HISTORIC AND DESIGN REVIEW COMMISSION

HDRC CASE NO: 2020-468

ADDRESS: 1009 S ALAMO ST

TYPE OF WORK: Construction of rear accessory structures, ADA ramp installation, landscaping and

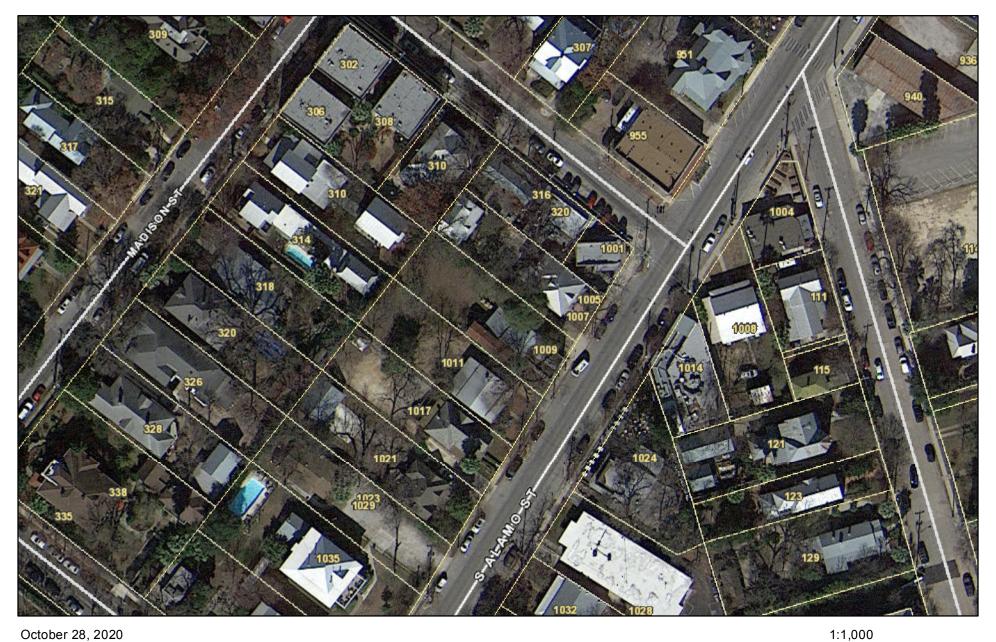
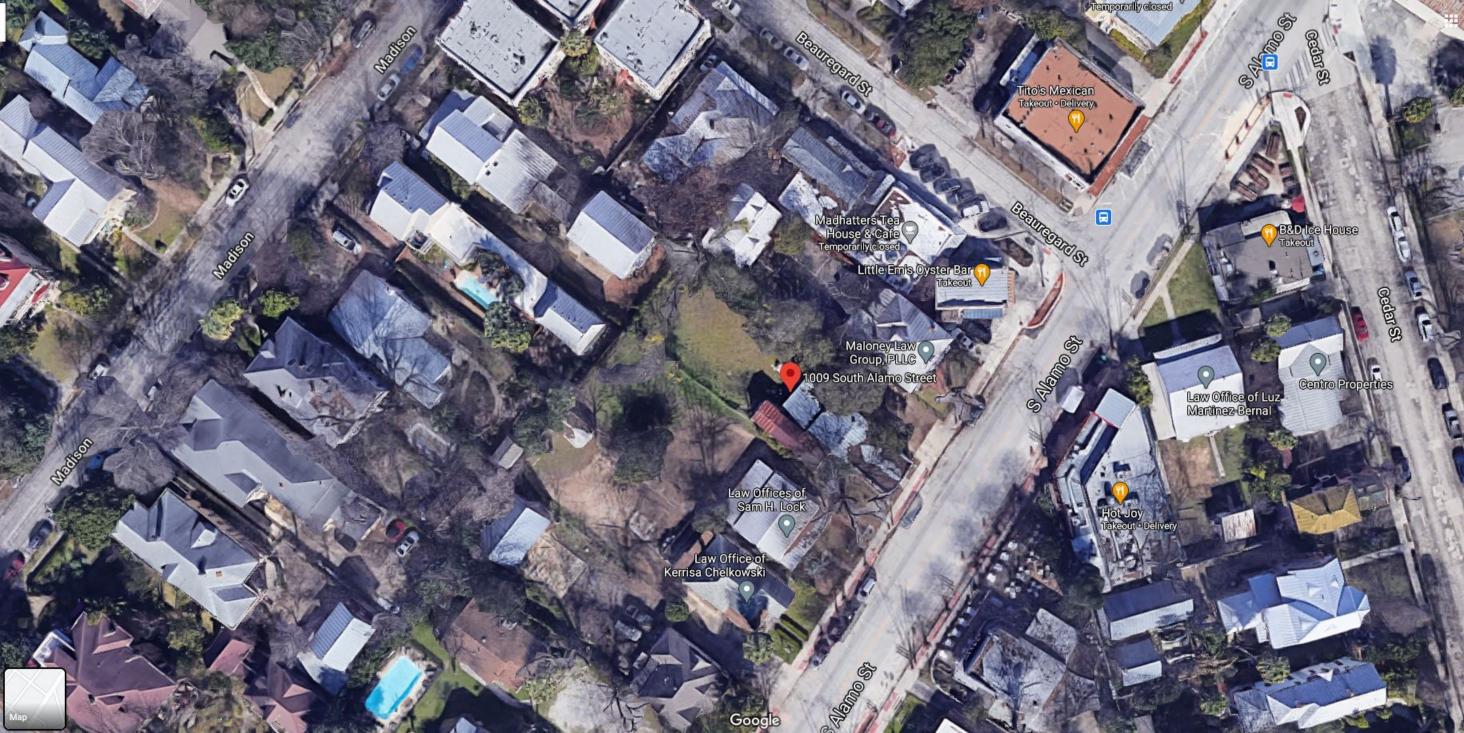
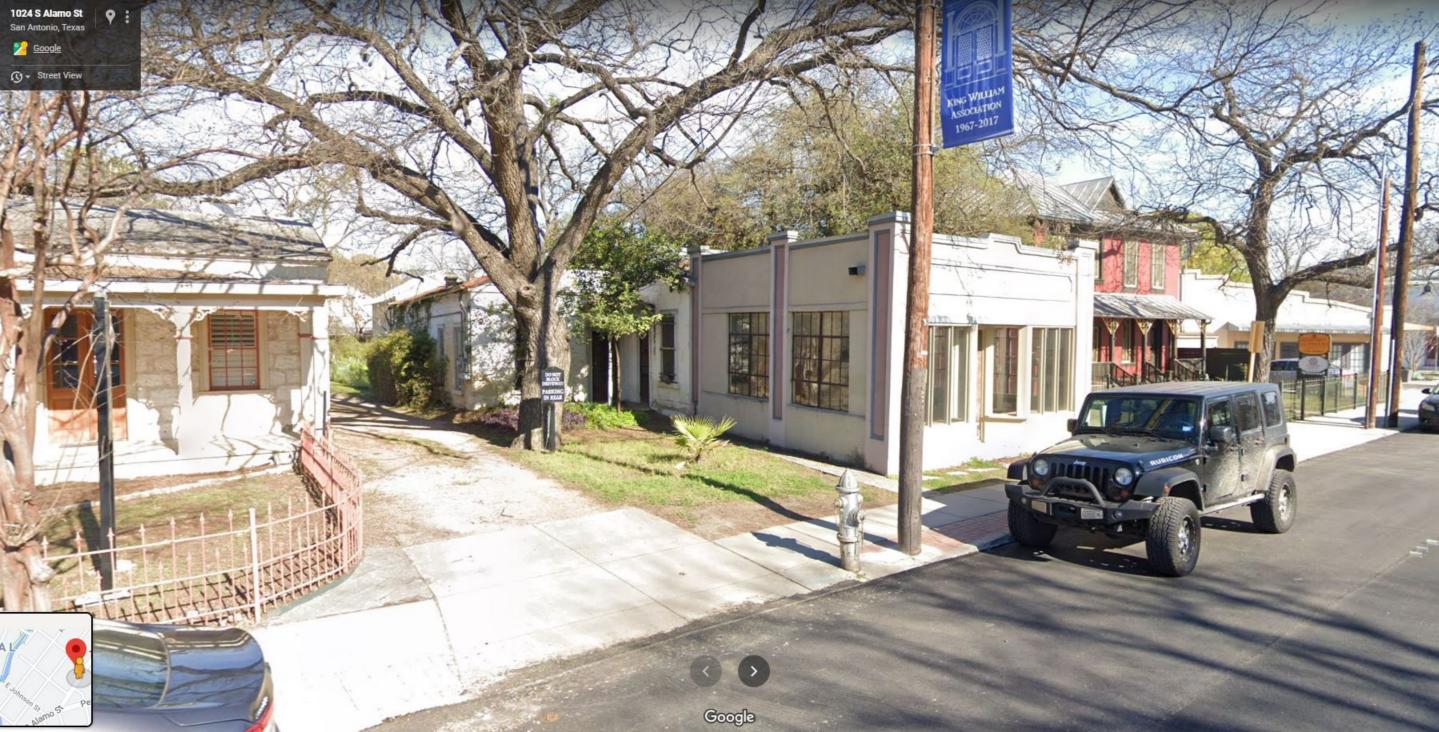
- f. CHARACTER The proposed rear accessory structure features T1-11 plywood panel siding, and a v-crimp metal roof and full width wood porch with simple square columns and 1x6 wood plank decking. Per the Guidelines for New Construction 5.A.iii., Relate new garages and outbuildings to the period of construction of the principal building on the lot through the use of complementary materials and simplified architectural details. Staff finds that the v-crimp metal roof and simple wood construction porch decking and columns are appropriate for a rear accessory structure. However, staff finds that horizontal wood lap or smooth Hardie lap siding with 4 inch exposure or vertical board-and-batten siding with 12 inch panels to be more appropriate than the T1-11 plywood panel siding.

- g. WINDOWS & DOORS The proposed rear accessory structure features aluminum windows with faux divided lites and a 9-lite aluminum door. Per the Guidelines for New Construction 5.A.iv., applicants should design window and door openings to be similar to those found on historic garages or outbuildings in the district or on the principle historic structure in terms of their spacing and proportions. Staff finds the proposed steel door with a true divided 9-lite design to be appropriate. However, staff finds that the proposed windows do not adhere to *Standard Specifications for Windows for New Construction* regarding trim, sash profiles, faux divided lites, and nailing fin installation.

the attending members proposed the following treatments to address the two outstanding stipulations: (i) the installation of wood window screens and/or shutters to mitigate the visual impact of vinyl windows with faux divided lites, and (ii) the installation of wood batten pieces on the existing T1-11 siding, painted to match, to mimic a traditional board-and-batten siding profile. Staff concurs with the comments from the DRC site visit and find that due to the impermeant nature of the prefabricated structure, the proposed treatments would appropriately address the previously cited outstanding stipulations.

- i. That the applicant installs of wood window screens and/or shutters to mitigate the visual impact of vinyl windows with faux divided lites per the Design Review Committee comments noted in finding i.
- ii. That the applicant installs wood batten pieces on the existing T1-11 siding, painted to match, to mimic a traditional board-and-batten siding profile per the Design Review Committee comments noted in finding i.
